**ADDENDUM NO. 1**  
**to**  
**Bidding Documents for:**  
**Town of Wareham, MA**  
**Installation of Low-Pressure Sewer Force Main**  
**Contract 2022-001**

**TOWN OF WAREHAM, MA  
INSTALLATION OF LOW-PRESSURE SEWER FORCE MAIN  
CONTRACT 2022-001**

**Pre-Bid Meeting  
August 10, 2022 – 10:00A.M.**

**Construction Details Sheet CD-1**

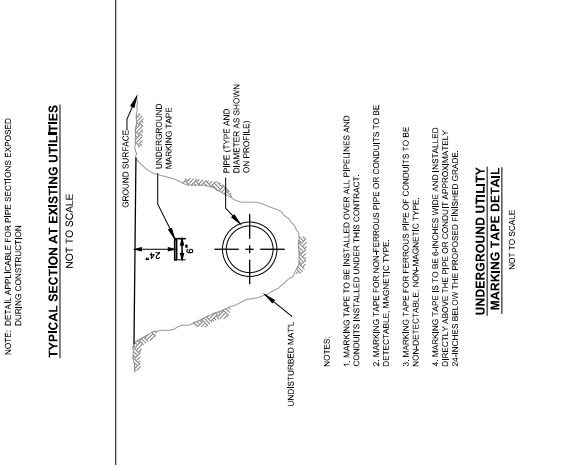
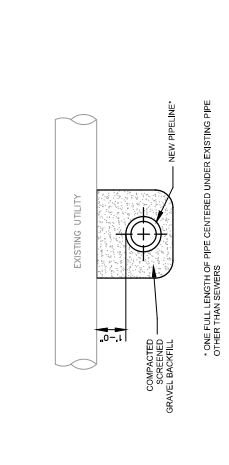
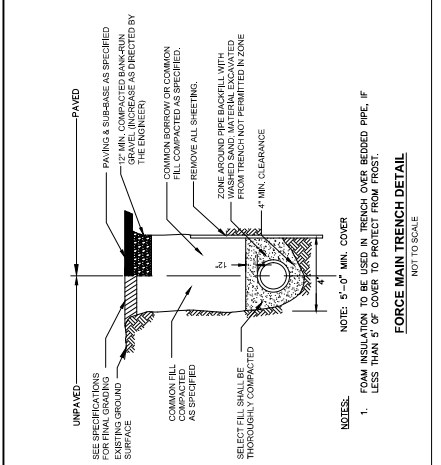
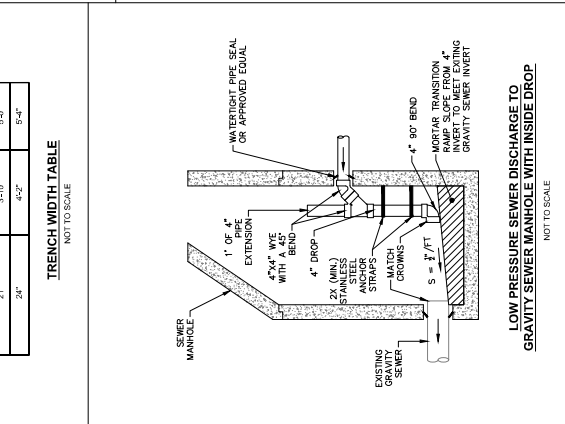
Delete sheet CD-1 in its entirety and insert the attached revised sheet CD-1. Changes are shown with yellow callouts.

2. **Q:** Referencing the detail for a sewer service on sheet CD-1 calls for a stainless steel corporation coming off a tee. With the main line being HDPE should a tapping saddles be used?

**A:** Manholes not called out as being air release manholes on the plans are cleanout manholes. See plan sheet CD-1 for manhole details.

**A:** The pumps are not to be installed inside the pump station tanks, the electrical conduit, vent pipe and gravity service pipe are to be installed as shown on the grinder pump station detail on plan sheet CD-1. Also see spec section 01015 part 1.03 for further detail.

**A:** Threaded stainless steel ball valves are acceptable for use inside low-pressure sewer manholes. See low-pressure structure details on plan sheet CD-1.

**A:** HDPE tees or tapping saddles may be used for the sewer services and stainless steel corporation stops can be installed on the service line in close proximity to the tee.
